Access Compliance Report

Public Rights-of-Way

Main Street: IRVINE_BLVD Cross Street: HOLT_AVE Location: NW

ADA ID: RPRK211011142008 Ramp Type: Type 1 - Perpendicular Diagonal Initial Pass/Fail: Fail Overall Compliance: No Severity Score: 2

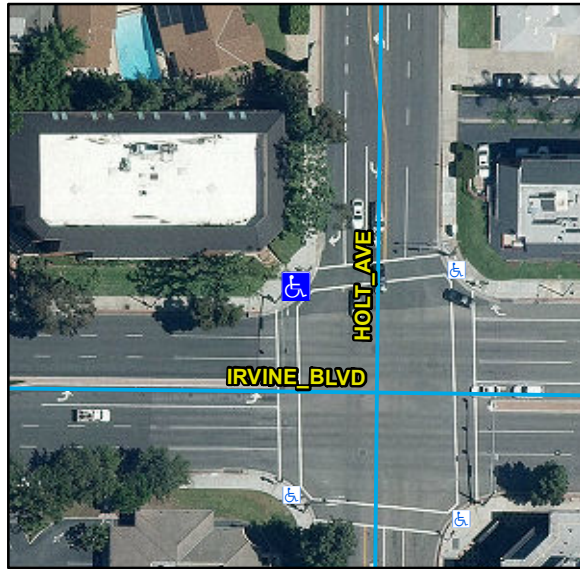
R304.5.3, STD 1115

Remove & Replace Curb Ramp With Two New Directional Ramps or Equivalent.
